ARCATA WOODS SUBDIVISION

APPLICATION NUMBER 14 DATE August 17, 2006
APPLICANT Arcata Woods Subdivision
REQUEST Subdivision

ARCATA WOODS SUBDIVISION

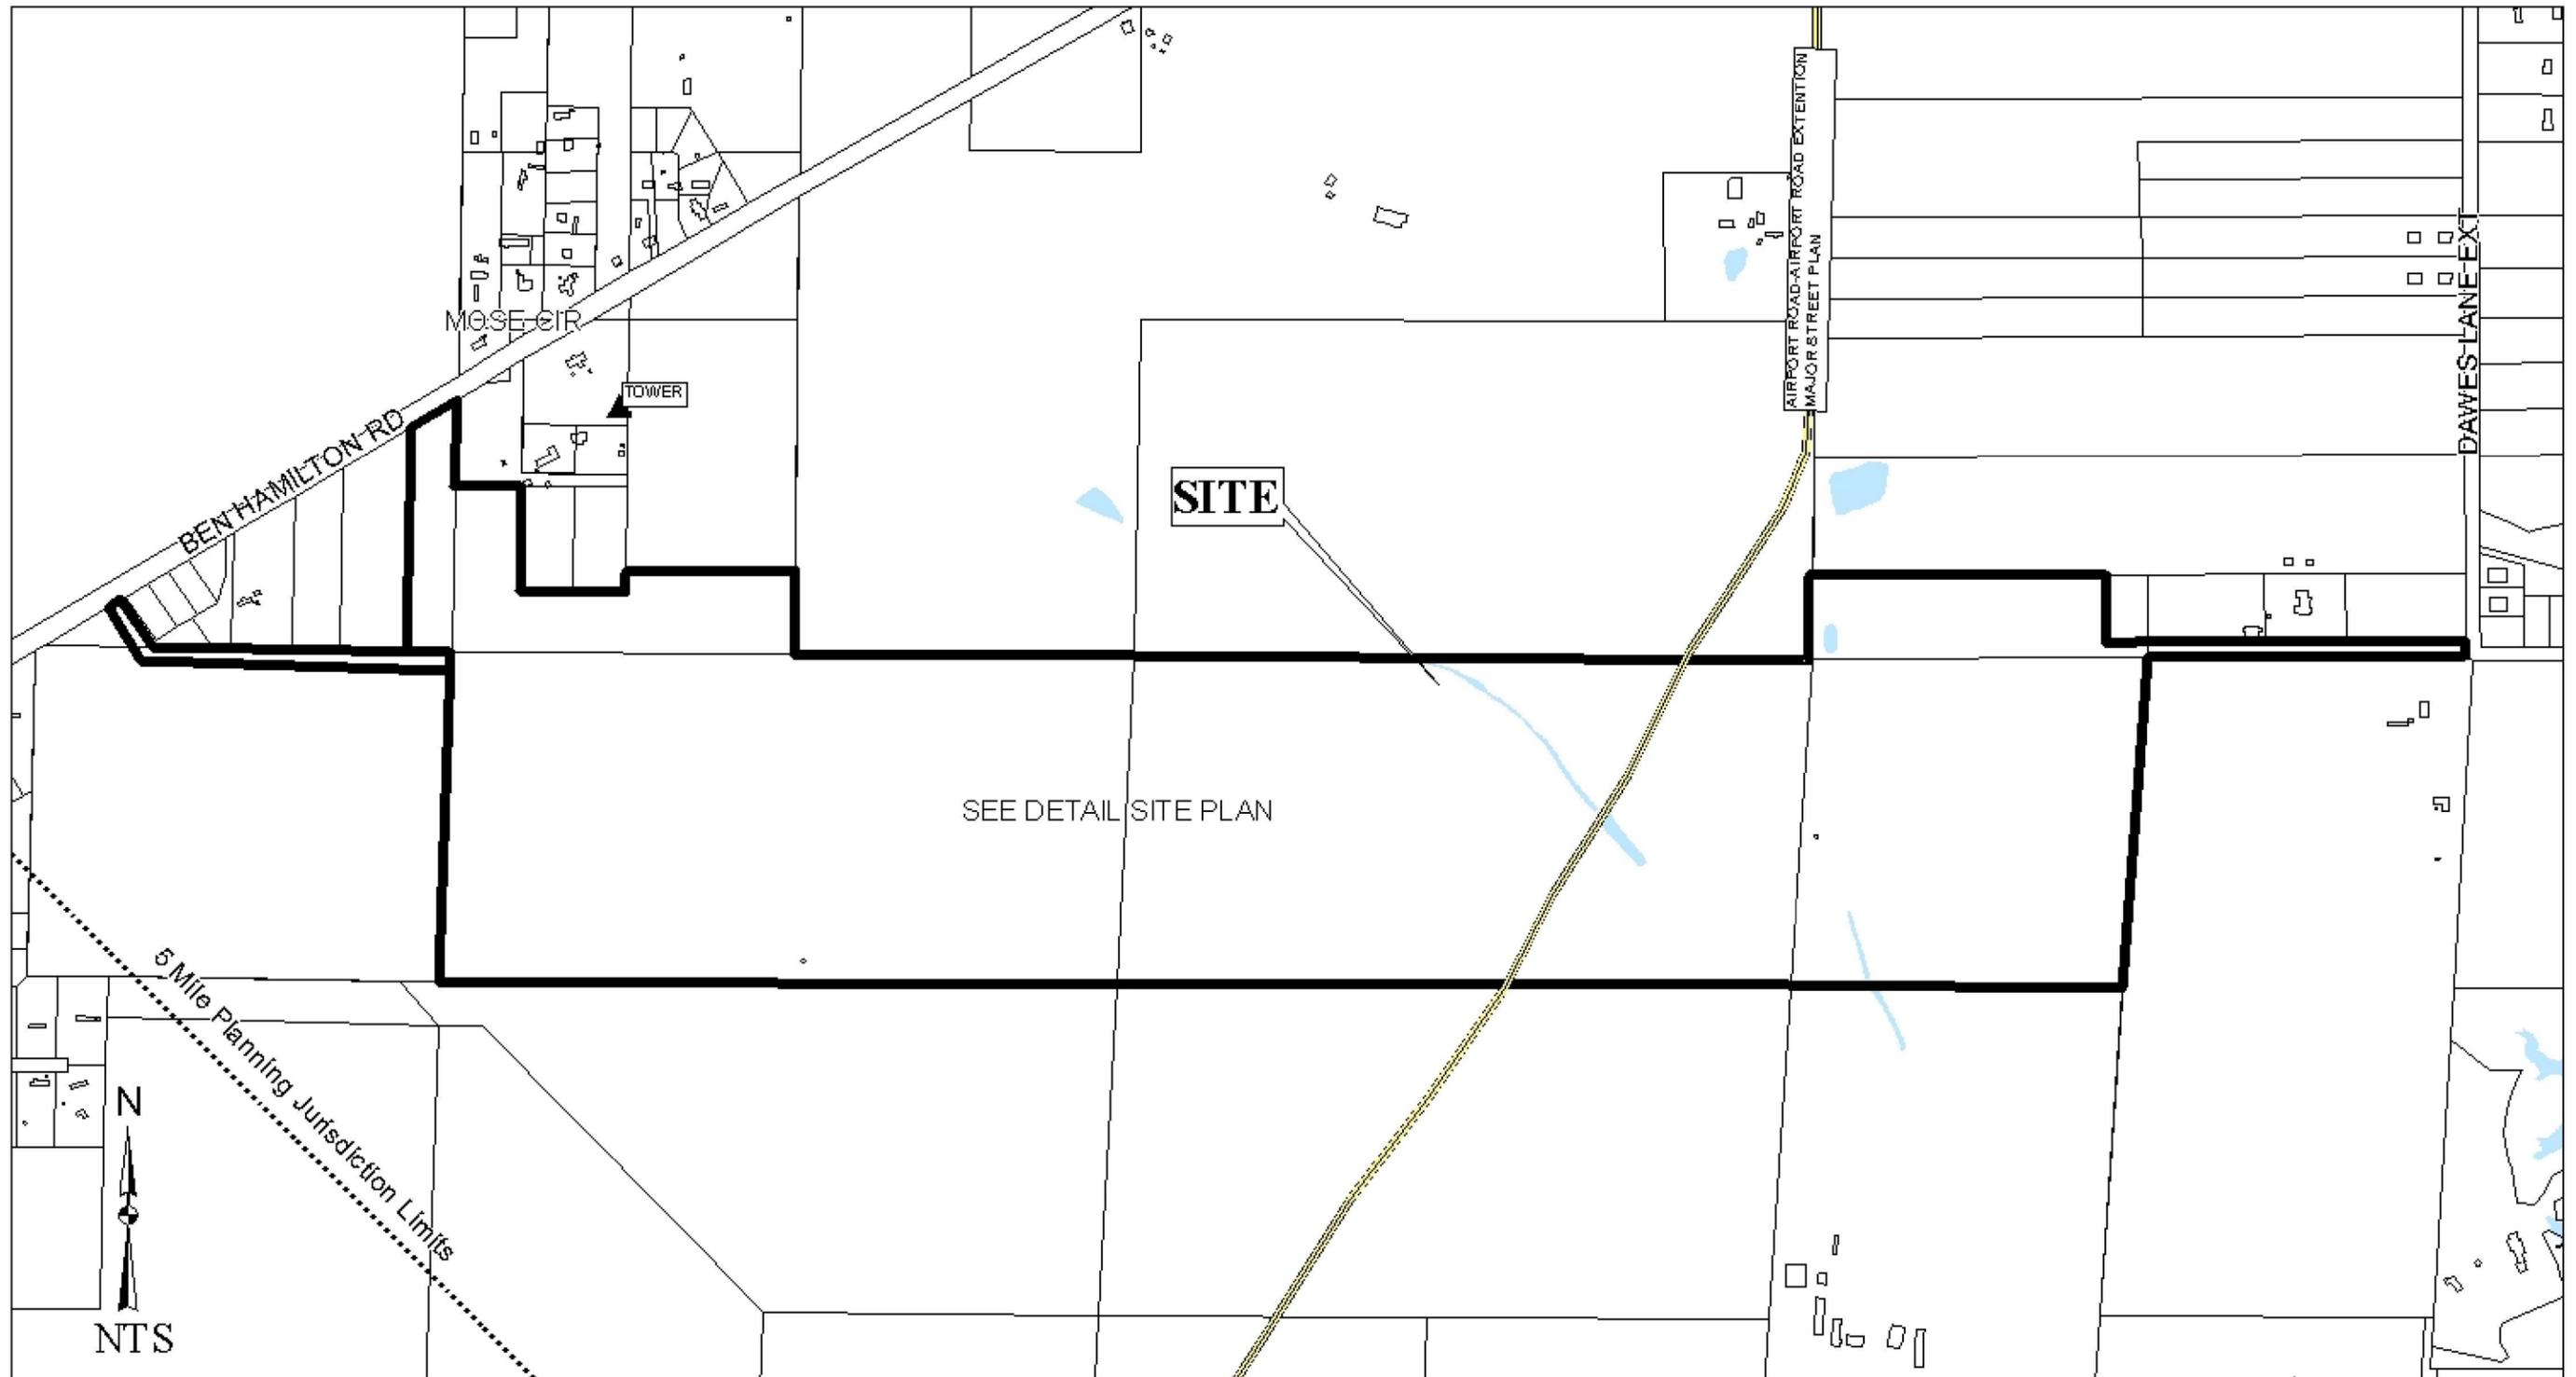
The purpose of this application is to create a 427-lot subdivision from five parcels and one lot. The preliminary plat depicts a total of eight phases, with from 40 to 100 lots per phase. It should be noted that a count by staff of the lots depicted on the preliminary plat results in 446 lots, rather than 427 lots as labeled on the plat.

While the site does not have any frontage on existing major streets, the proposed Airport Road – Airport Road Extension major street bisects the site. According to the Major Street Plan component of the Comprehensive Plan, the right-of-way for the proposed Airport Road – Airport Road Extension major street should be 100-feet in width. Therefore, the preliminary plat should be revised to accommodate the proposed major street.

The proposed 60-foot roadway connection on the East side, linking the first phase of the site to the intersection of Dawes Lane Extension and Belmont Park Drive, appears to include property for which no letters of authorization are included within the application packet. As the proposed roadway would result in the subdivision of land from these parcels, the applicants must provide evidence that the owners of these parcels have given their consent to subdivide their property. Furthermore, lots of record must be created for the parcels in question due to existing structures on the properties.

A 60-foot wide roadway easement on the West side of the site is included in the legal description for the site and depicted on the preliminary plat. Access to the site via this easement should be denied, or the parcel in question should be included as part of the application, and the easement provided as a legitimate public right-of-way or private street.

Multiple traffic calming devices have been depicted on the preliminary plat. Communication with the Mobile County Engineering Department indicates that additional traffic calming devices may be necessary due to the non-intersected straight length of some of the proposed roads.

Generally, blocks lengths provided within the development meet the minimum requirements of Section V.C.1. of the Subdivision Regulations. It should be pointed out that the roads surrounding the proposed “Phase Seven” essentially create a “superblock” with limited North-

South access within the development: an interior street linking “Phase Five” to “Phase Eight,” through “Phase Seven” would facilitate pedestrian, vehicular and emergency access within the development.

The overall site is bounded by between seven or eight land-locked parcels (the question of how many relates to the design of the proposed road on the Eastern side of the site). The development, as currently designed, appears to provide access or street stubs to three or four of these parcels. The subdivision should be redesigned to provide access to all land-locked parcels abutting the site.

Three detention areas are depicted on the preliminary plat. Two of the detention areas appear to either have frontage on a proposed street, or access from a street via a greenspace common area. The Eastern most detention area does not appear to be accessible via an easement or common area, and does not front a proposed street. The plat should be revised to provide some form of dedicated access to the detention area to allow maintenance of the detention facility.

It should also be noted that the Eastern most detention area is adjacent to an area of land over 12 acres in size, with no indication of its use or status as it relates to the development. There are also several smaller areas that are unaccounted for in terms of common area or development. The plat should be revised to fully account for and label all land included as part of the development.

The plat for the Duncan Subdivision, from which a lot will be used for the proposed development, depicts a drainage easement that is not reflected on the preliminary plat for this application. The preliminary plat should be revised to depict this easement.

As previously mentioned, the preliminary plat is labeled as providing 427 lots, yet repeated staff counts indicate a total of 446 lots. The discrepancy between the labeled and counted lots should be resolved.

It appears that each lot meets the minimum size requirements for developments with access to public water and sewer. Due to the size of the development, it is requested that the applicant revise the preliminary plat to provide the size of each lot in square feet on the plat, either as a table or as a label for each individual lot.

The 25-foot minimum building setback line, required in Section V.D.9., is not shown for the subdivision, but would be required on the final plat, if approved.

Greenspaces and detention areas are depicted on the preliminary plat. All common areas, whether greenspaces, detention areas, or other, should be labeled as such, and a note should be placed on the final plat, if approved, stating that maintenance of all common areas shall be the responsibility of the subdivision’s property owners.

Phasing for the development of the site appears to begin on the Eastern side of the site, depending upon an access road 1,300 ± feet in length linking the development to the intersection of Dawes Lane Extension and Belmont Park Drive. This end of the site is nearer to other major

streets such as McDonald Road and Theodore-Dawes Road West, however, it would seem more appropriate to Urban Development staff if the first two phases of development start on the Western side, at Ben Hamilton Road. Ben Hamilton Road appears to be better maintained, and thus better able to accommodate the considerable traffic that this development will generate due to the number of proposed lots.

Based upon the preceding, the plat is recommended for Holdover until the September 21st meeting, with revisions due to Urban Development by August 29th, for the following reasons: 1) revision of the plat to accommodate the proposed Airport Road – Airport Road Extension major street, including the necessary dedication of land to Mobile County; 2) provision of letters of authorization from all property owners that will have land directly impacted by the proposed development, specifically for the 60-foot road on the East side of the development; 3) provision of additional traffic calming devices, in consultation with the Mobile County Engineering Department; 4) provision of additional road connections, to provide internal connectivity in compliance with Section V.C.1. of the Subdivision Regulations; 5) provision of connections to all abutting land-locked properties, in compliance with Section V.B.1. of the Subdivision Regulations; 6) provision of access, via identified easement, green space or directly, to all detention areas depicted on the plat; 7) identification of all portions of the site to fully account for all acreage and the manner of site development; 8) depiction of any existing drainage easements associated with previous subdivisions (Lot 1, Duncan Subdivision); 9) resolution of the total number of lots so that the number depicted on the plat reflect the number claimed on the application; 10) identification of the size of all lots in square feet, either via a table on the plat, or by the labeling of each lot, to ensure that each lot meets the minimum lot size identified in Section V.D.2. of the Subdivision Regulations; 11) depiction of the 25-foot minimum building setback line, in conformance with Section V.D.9. of the Subdivision Regulations; 12) identification and labeling of all common areas, including greenspaces, road medians, and detention areas, and placement of a note on the plat stating that maintenance of all common areas shall be the responsibility of the subdivision's property owners; 13) rephrasing of the development to start from Ben Hamilton Road, or provision of a written explanation regarding the phasing scheme for the subdivision; 14) placement of a note on the final plat stating that any lots which are developed commercially and adjoin residentially developed property must provide a buffer, in compliance with Section V.A.7. of the Subdivision Regulations; 15) revision of the legal description, if necessary, to correct any errors associated with locating the point of beginning, and provision of the correct parcel numbers for the entire site; and 16) placement of a note on the plat stating that access to the 60-foot roadway easement on the West side of site is denied, or inclusion of the parcel to provide a legitimate means of access as a public or private street.
